Agenda Report

Date: August 20, 2024
To: Brian Saeki, City Manager
From: Kyle Cason, Public Works Director
Subject: Greenleaf Promenade

- Questions & Answers
- Carbon Sequestration
- Plan Revisions
 - *Tree Sizing*
 - *Shade Structures*
 - *Phasing*

Plan Revisions Tree Sizing

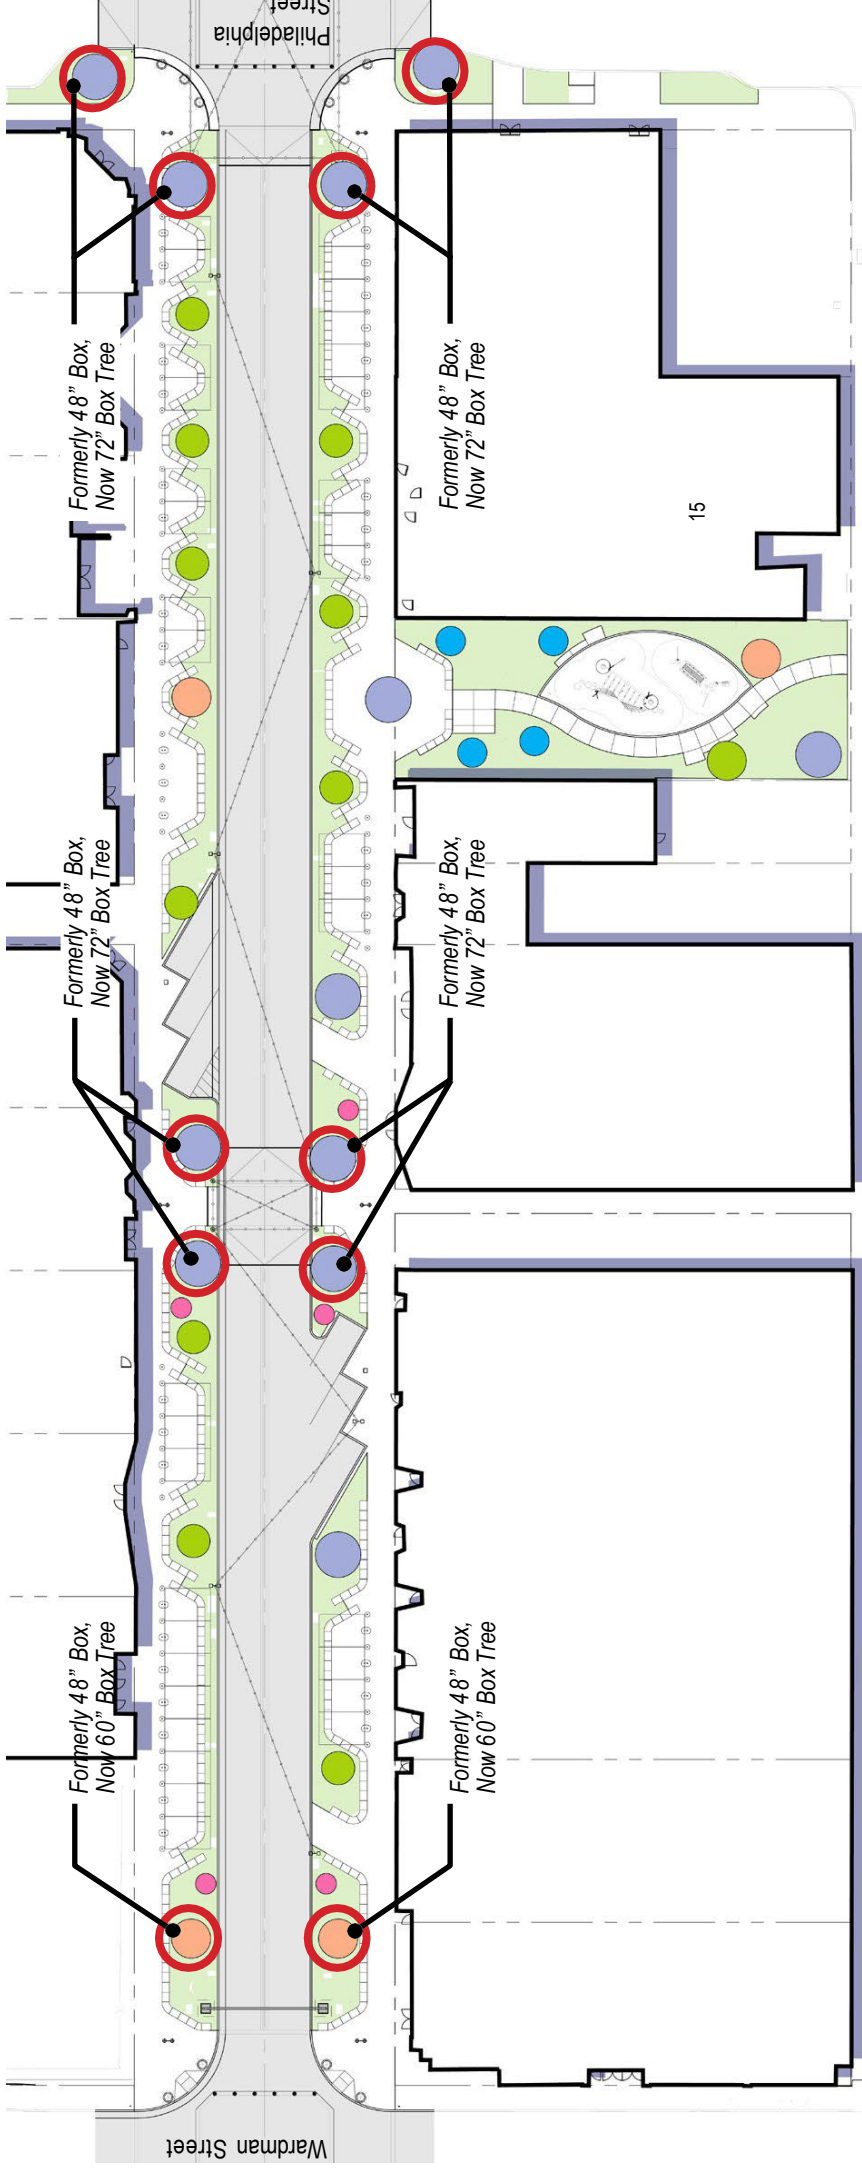
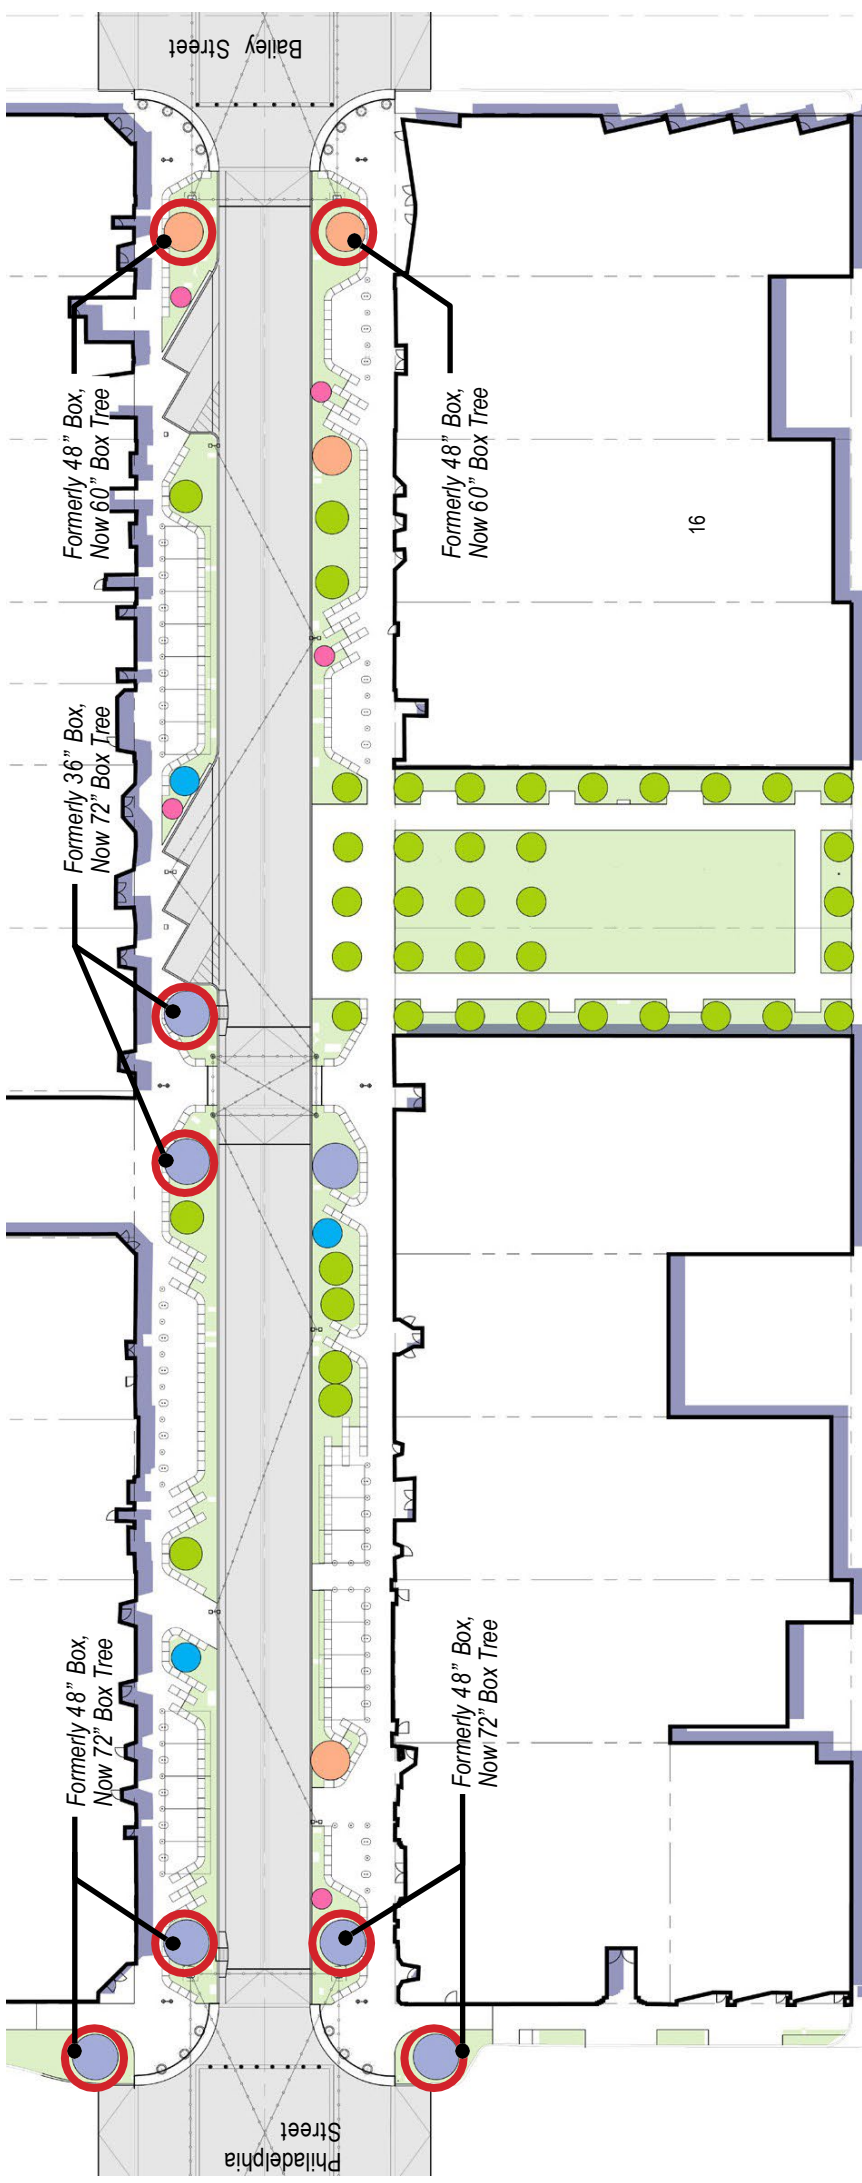
41. Plant 48-inch box trees, no smaller.

Answer: The tree sizes proposed for the project are as follows:

Existing Tree Overlay

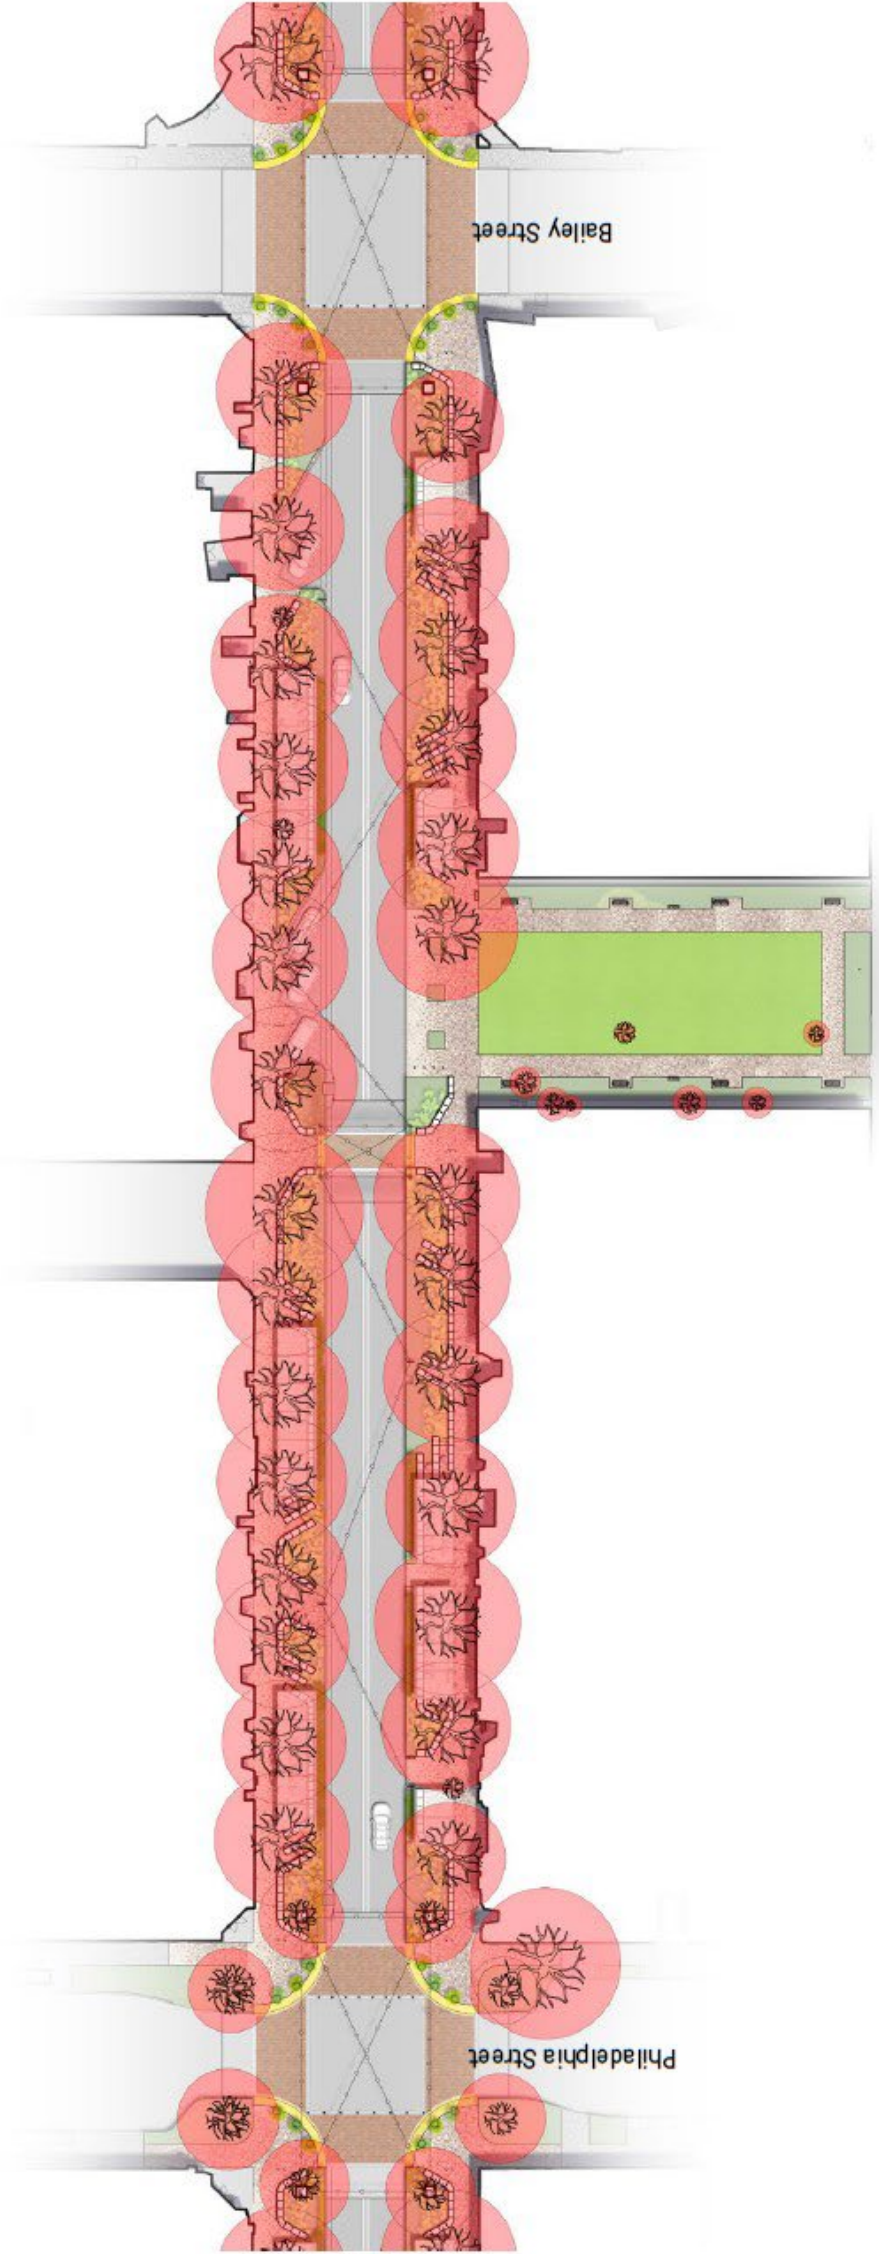
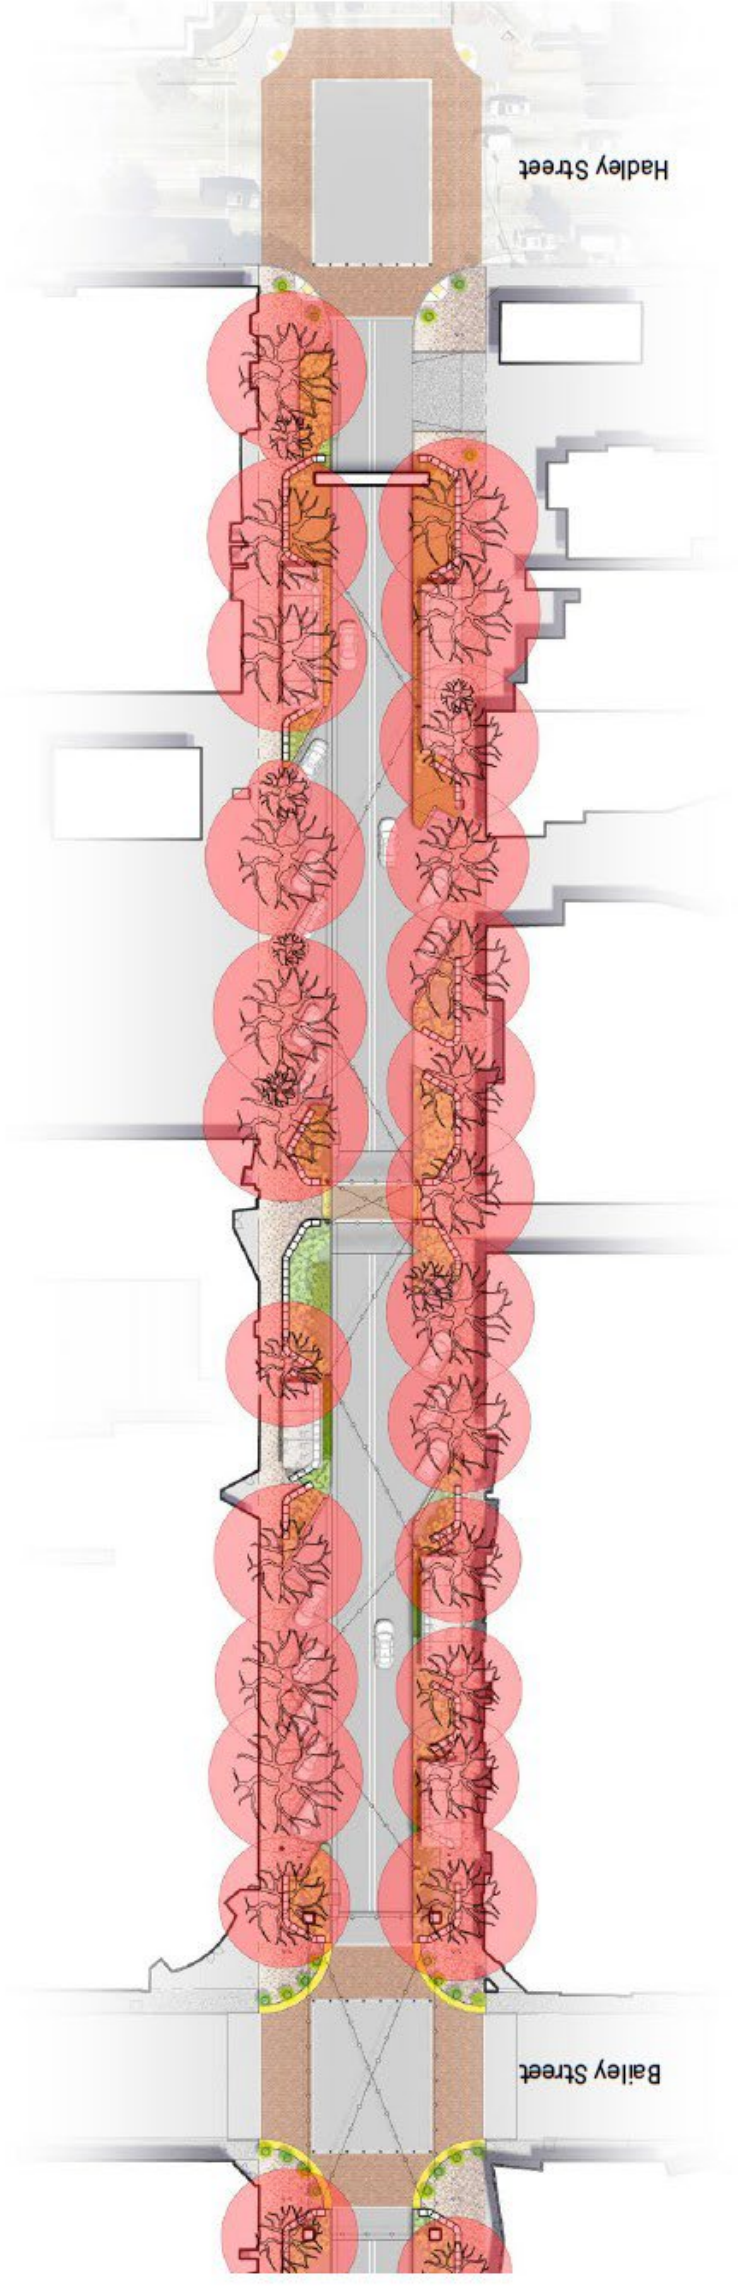
7. A significant number of Ficus trees could be saved and maintained by pouring new concrete surrounding uplifting roots instead of using pavers in the areas around those trees.
8. Sidewalks could be designed to extend into the street without sacrificing all the Ficus trees.
9. Some pavers could be used decoratively, similar to what exists now.
10. Tree Index notes the designated replacement trees for the three blocks of Greenleaf Ave in the Promenade Plan as laurel fig/Ficus trees.
11. Why wasn't SWA provided with the Tree Index list and the Appendix to the Uptown Specific Plan in making decisions about tree succession, phasing of tree removal, and selection of replacement trees?
12. Why are the proposed "future" pocket park's trees (34) considered as replacements for the Greenleaf trees when not part of the project?
13. Do not remove any camphor trees.

Answer: This is not feasible, as the tree protection zones extend into the street, and the Fire Department requires a 26-foot minimum clearance on the drive lane.
